Addendum No.2
to
CONSTRUCTION DOCUMENTS
for

June 2, 2025
2023159.00

NCISD New District Administration Building
21330 Valley Ranch Parkway
New Caney, TX. 77357
June 2, 2025

I-120

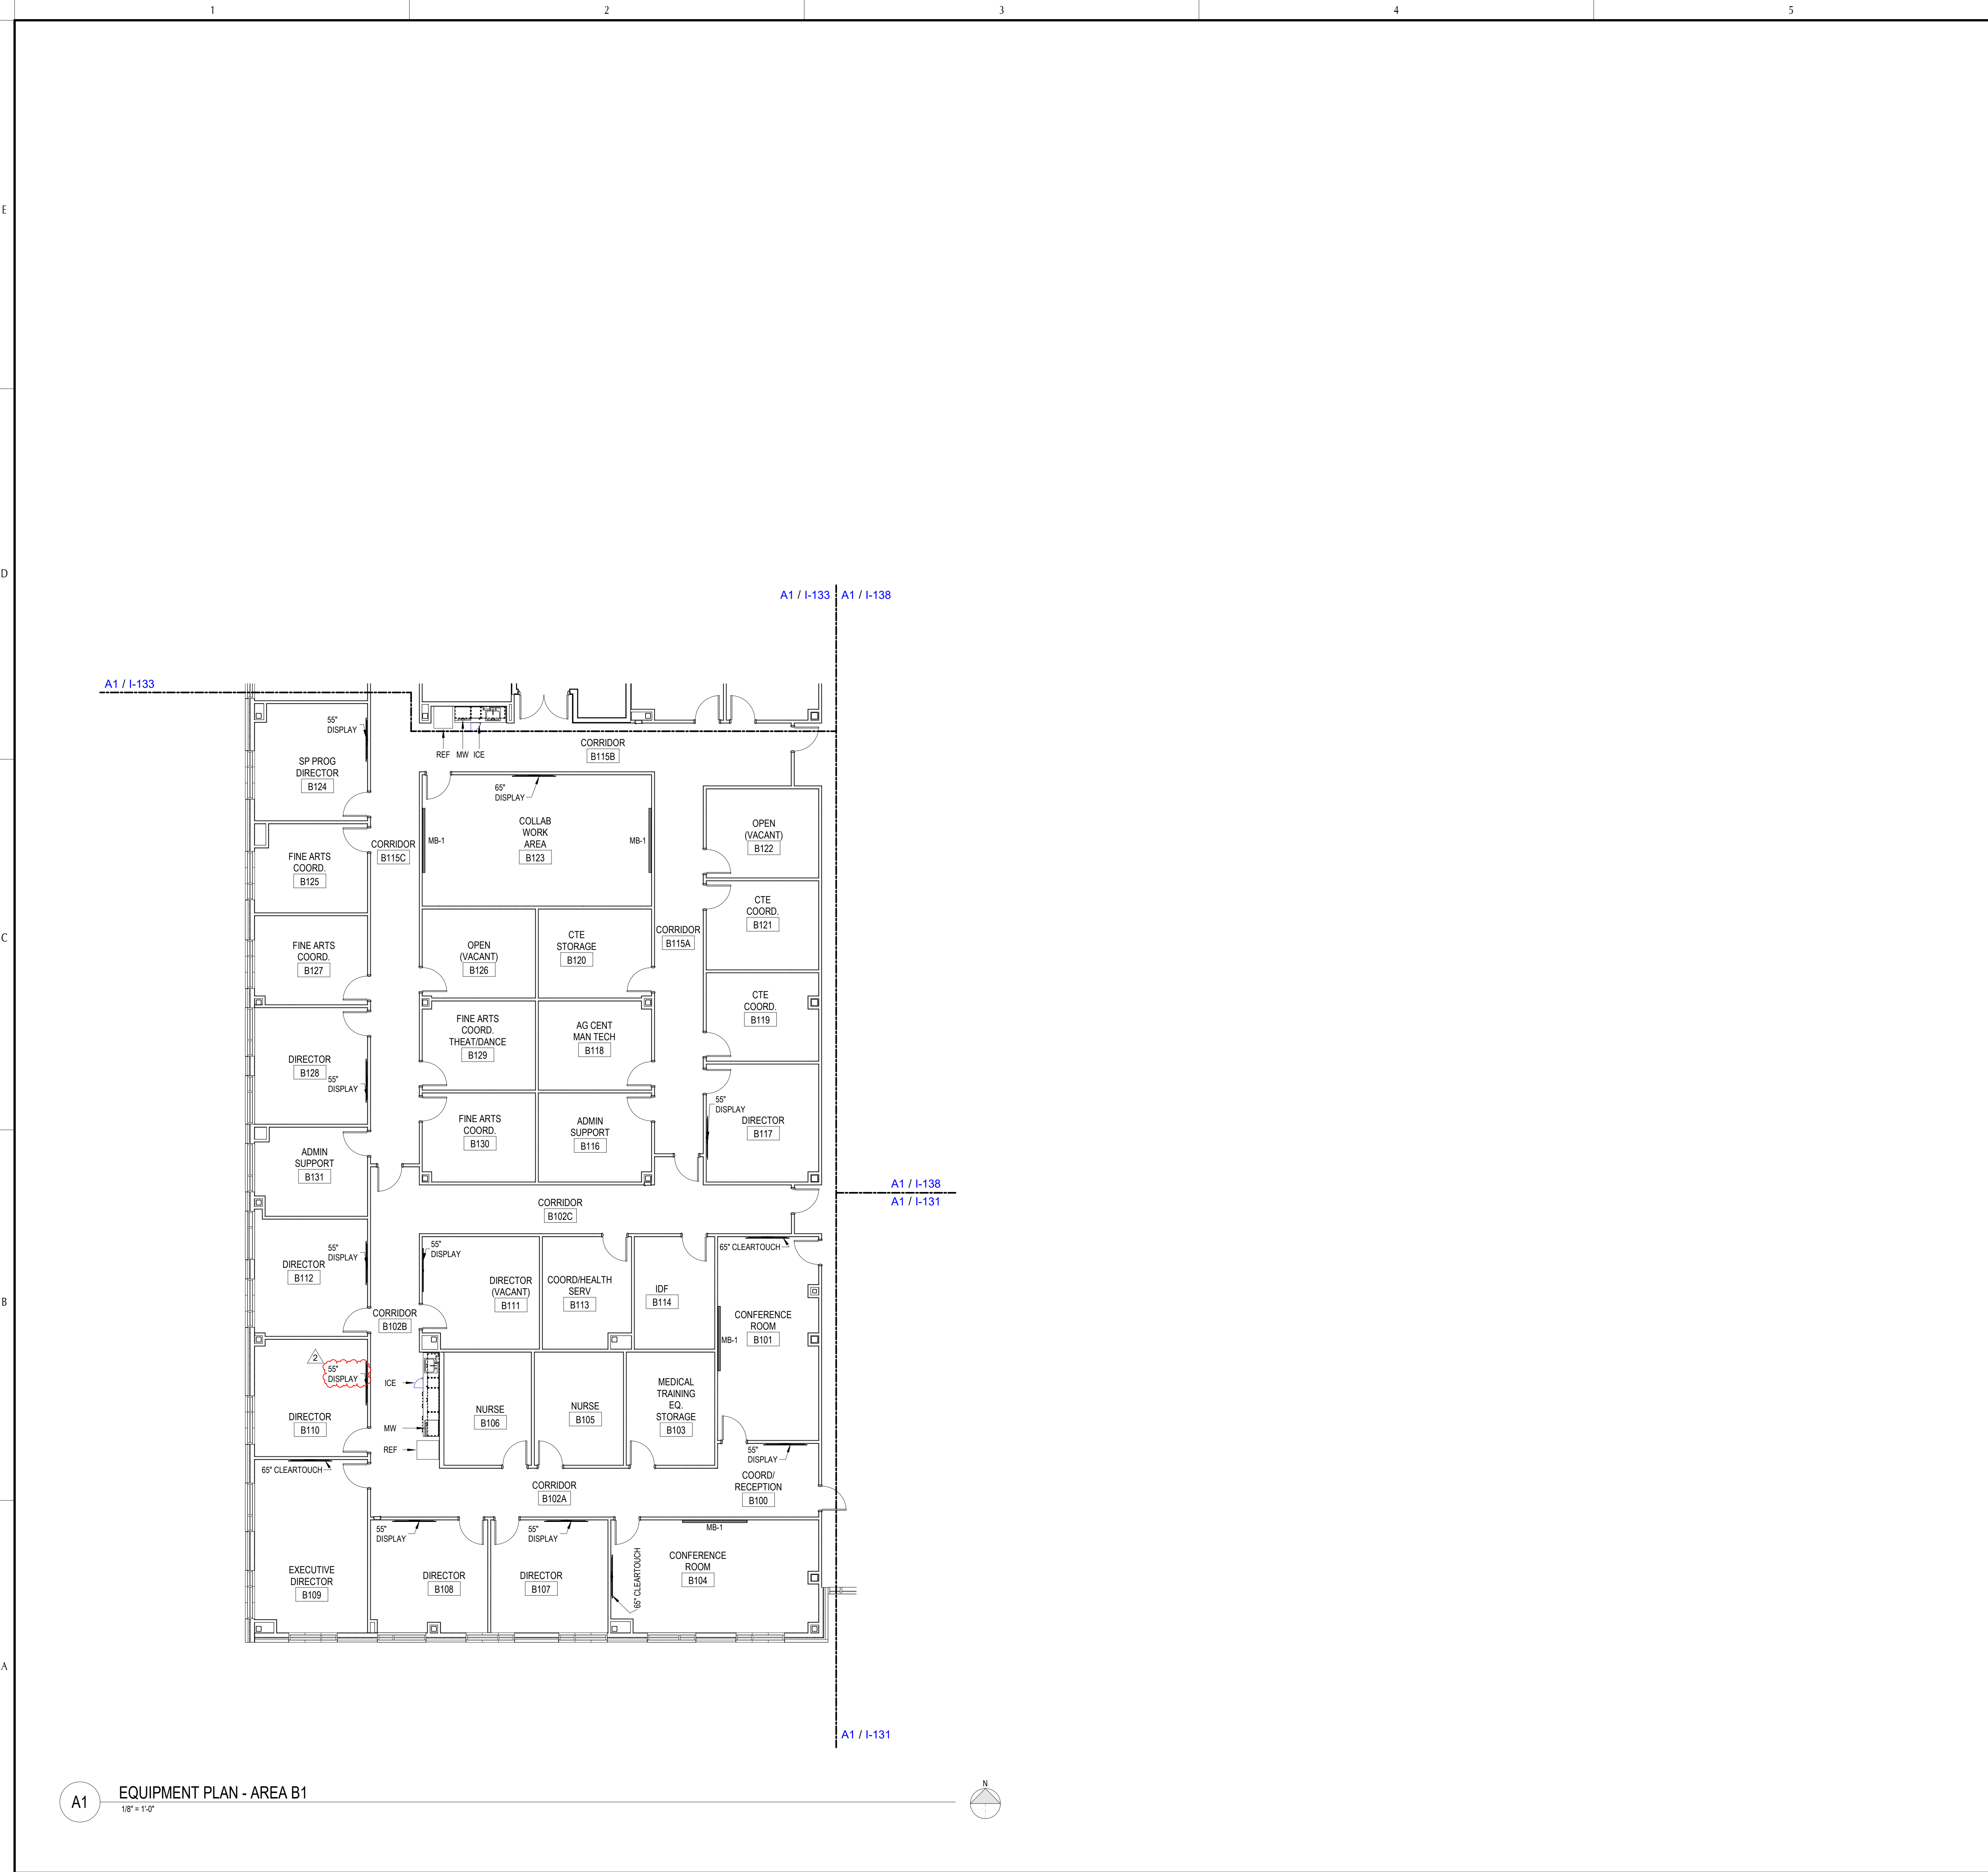
- a. Details A1 and A3 update to reflect the change in location of the shower. Floor tile added to shower. Note added that reads "1/2" TEMPERED GLASS WITH 42" TEMPERED GLASS DOOR USING SCHLUTER DECO SG 1/2"".

E-105-D1

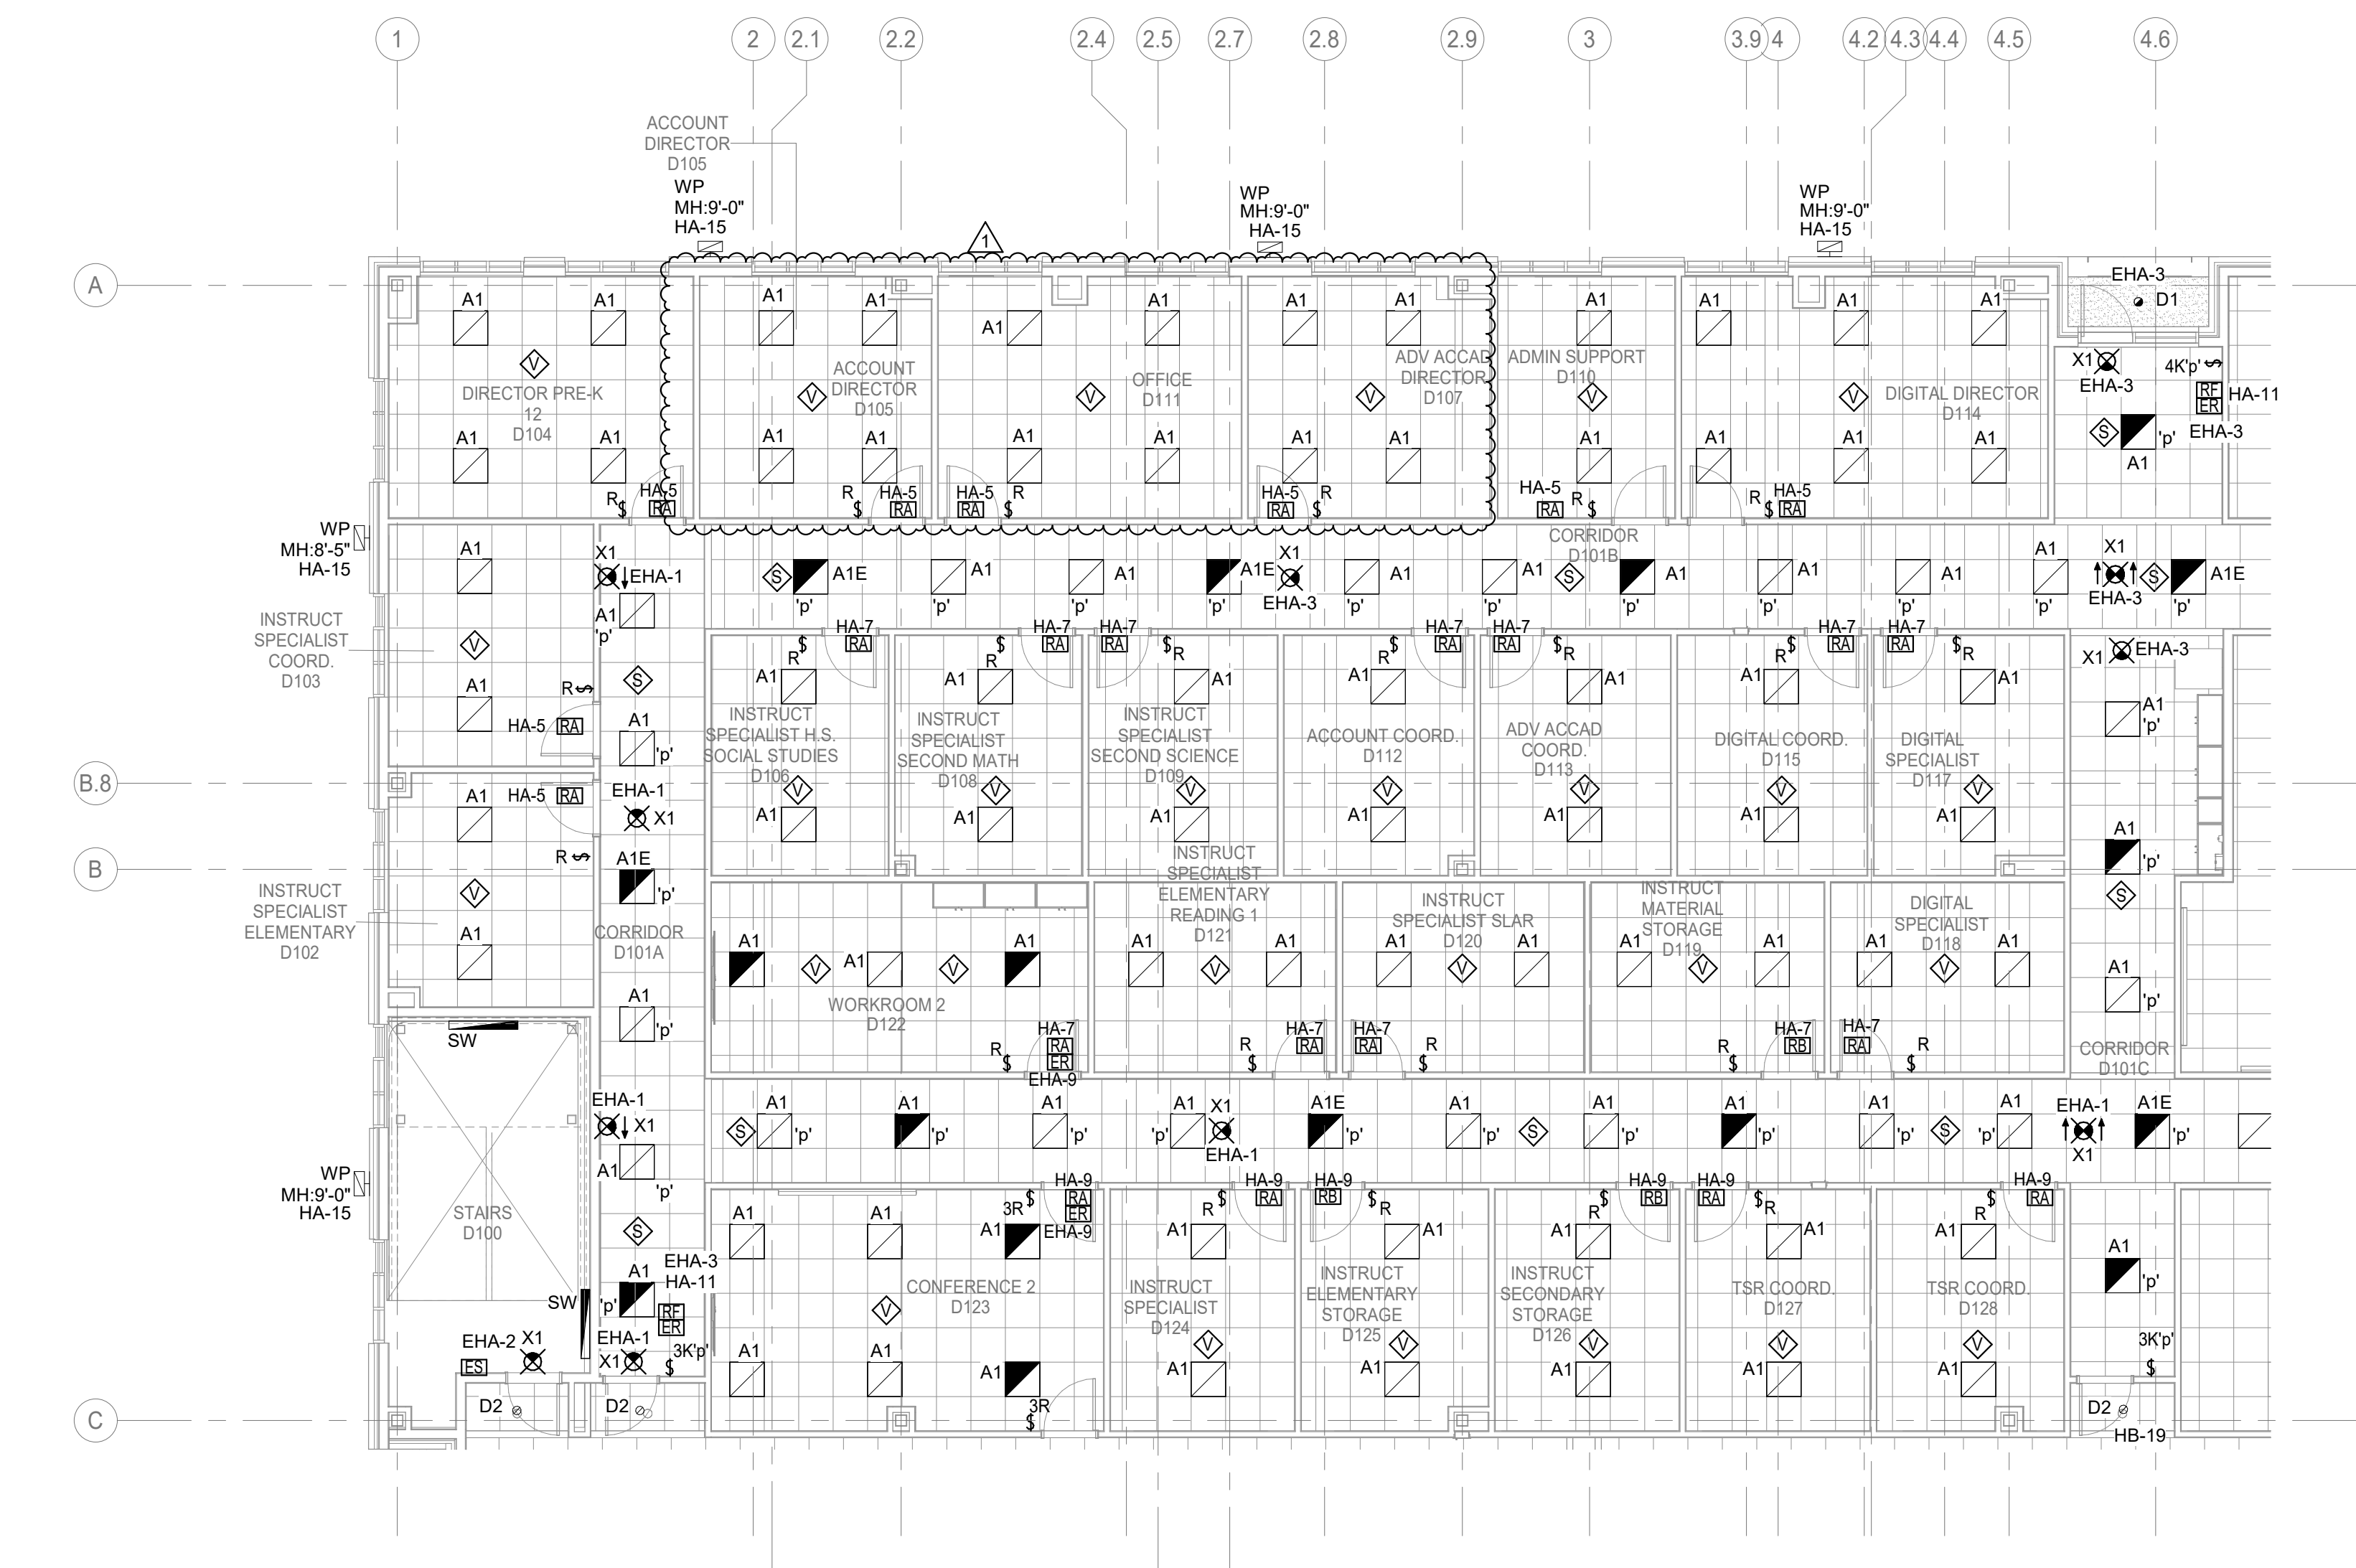
- e. Grille Schedule: Add remark #1: NO FACE MOUNTED OPPOSED BLADE DAMPER.
- 6. SHEET E-105 – D1 – ELECTRICAL FIRST FLOOR AREA – D1
 - a. Revise electrical lighting layout per architectural update.

TECHNOLOGY ENLARGED SITE PLAN

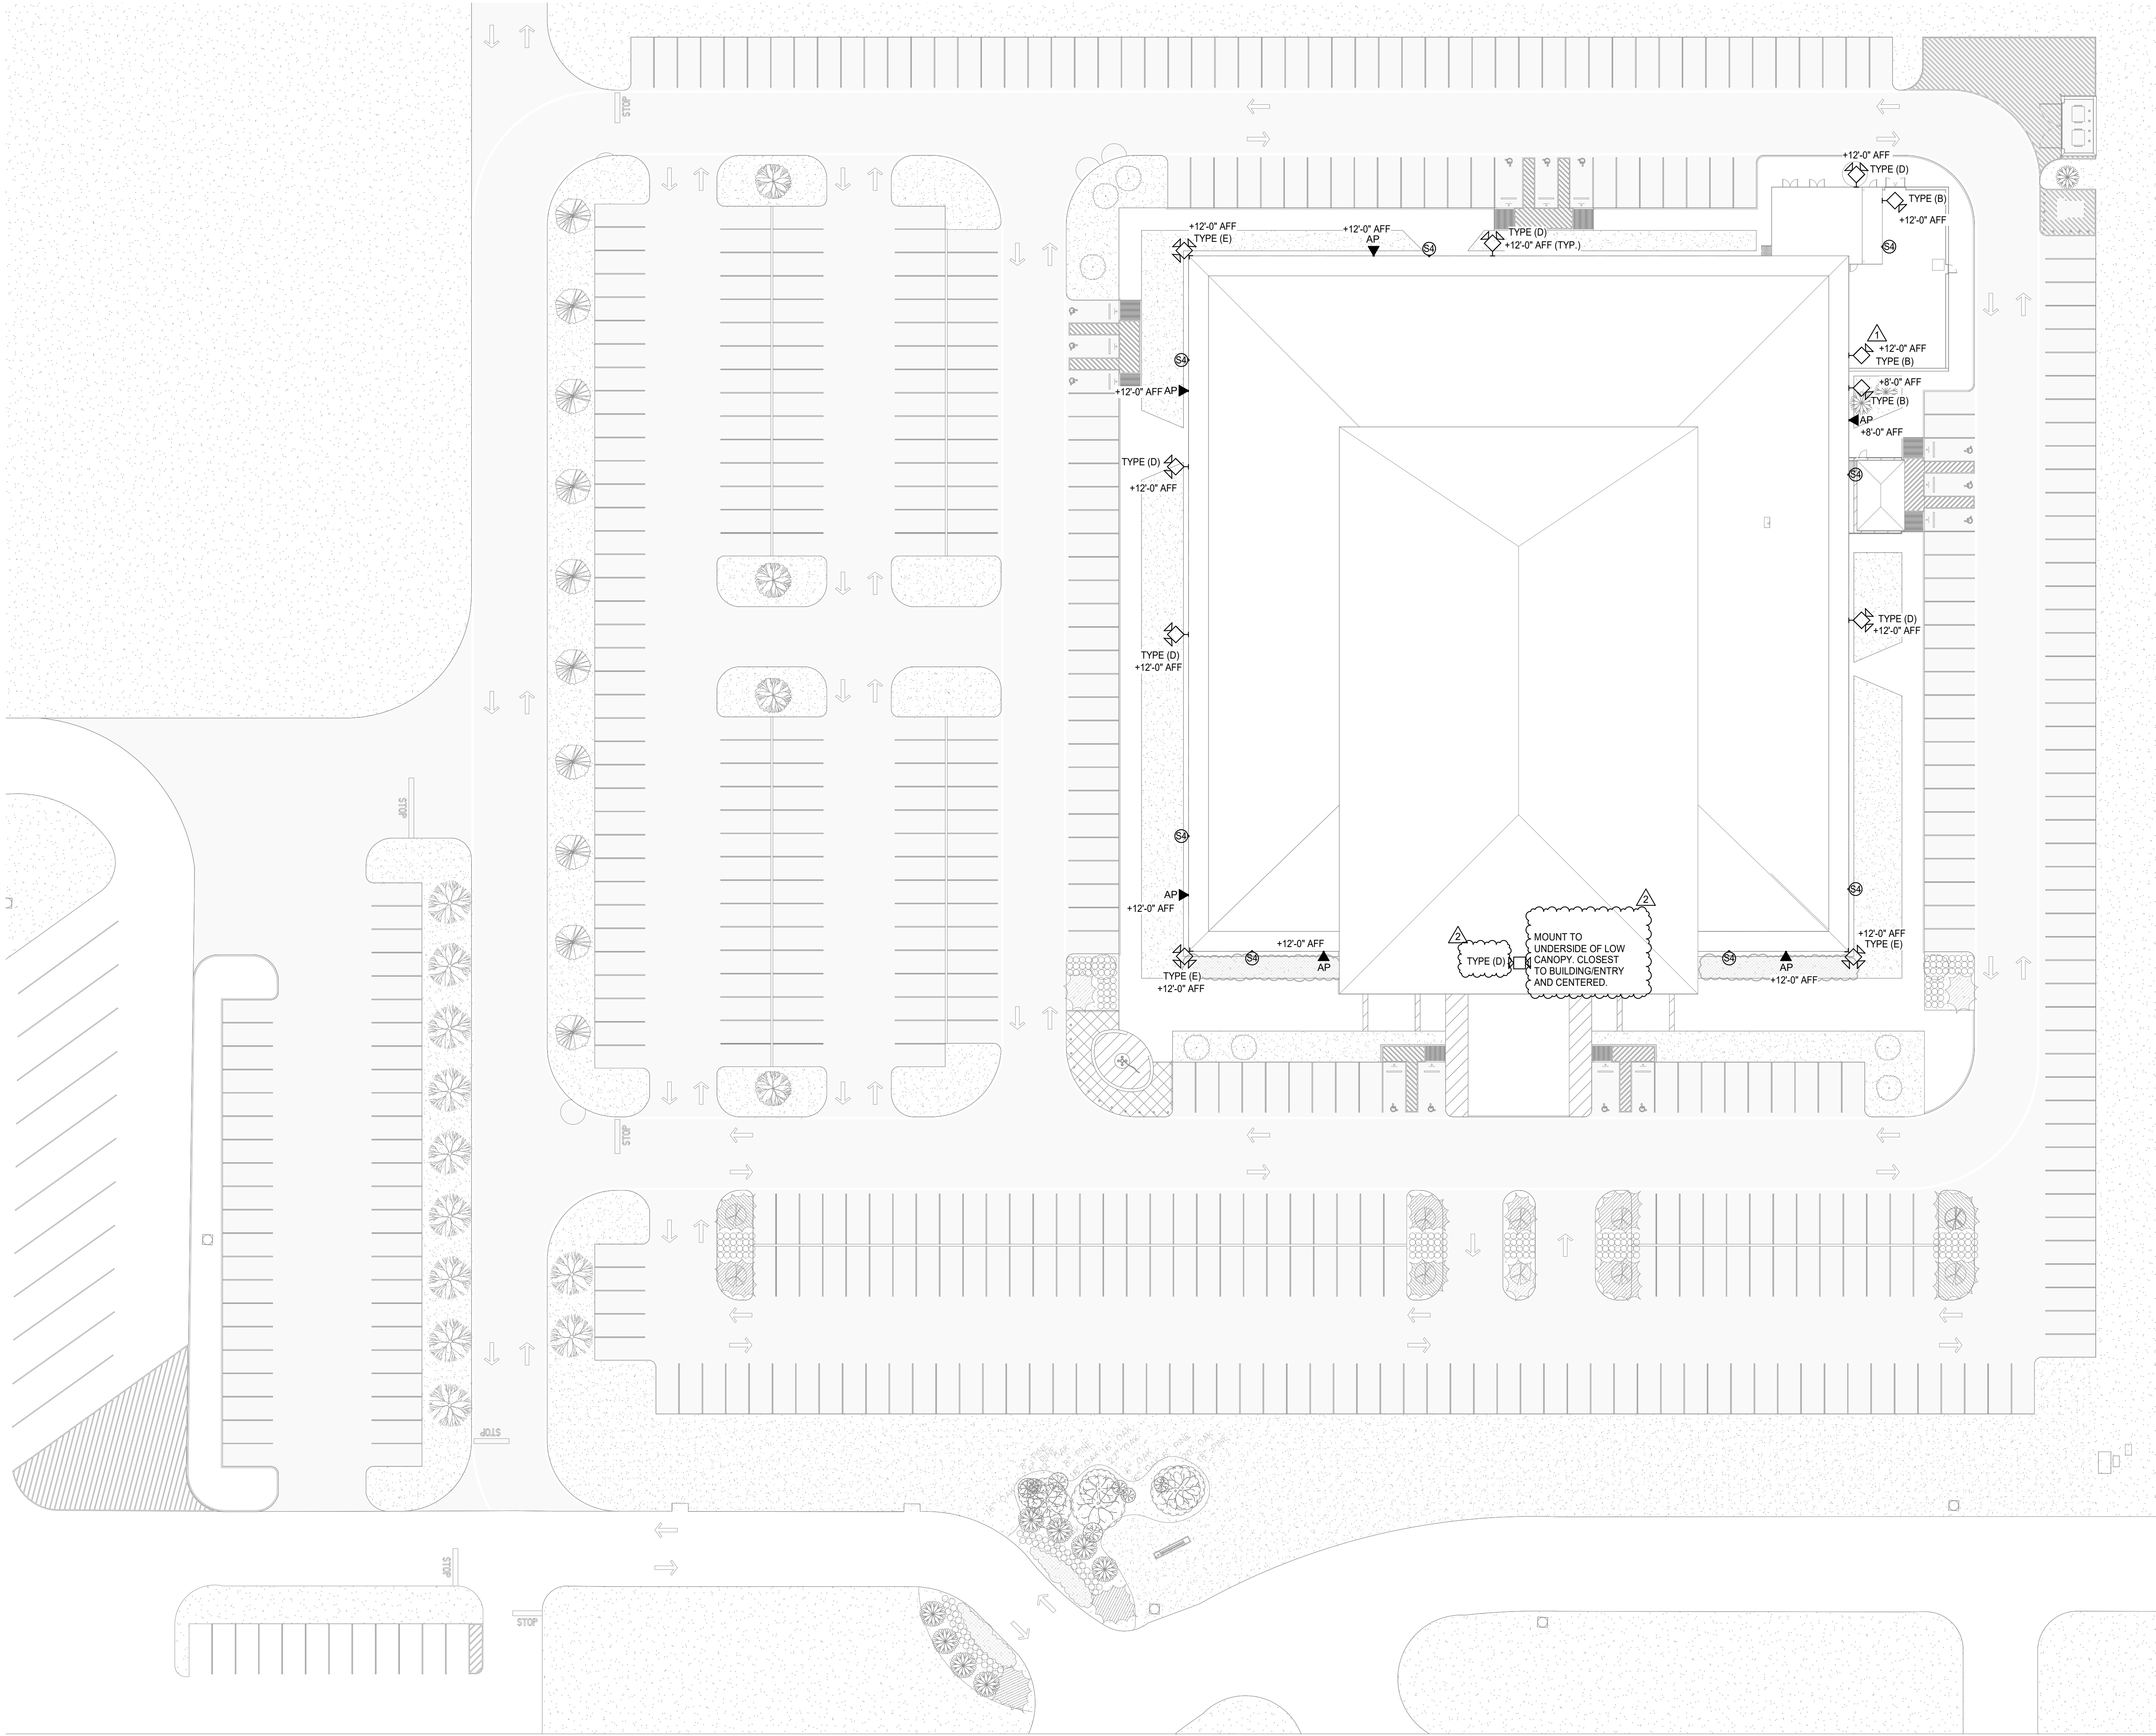
- a. Revised clouded camera type.
 - b. Revised clouded camera mounting note.
 - 12. SHEET T-103-A1 - TECHNOLOGY FIRST FLOOR AREA - A1
 - a. Revised wireless access point 'AP' layout as shown.
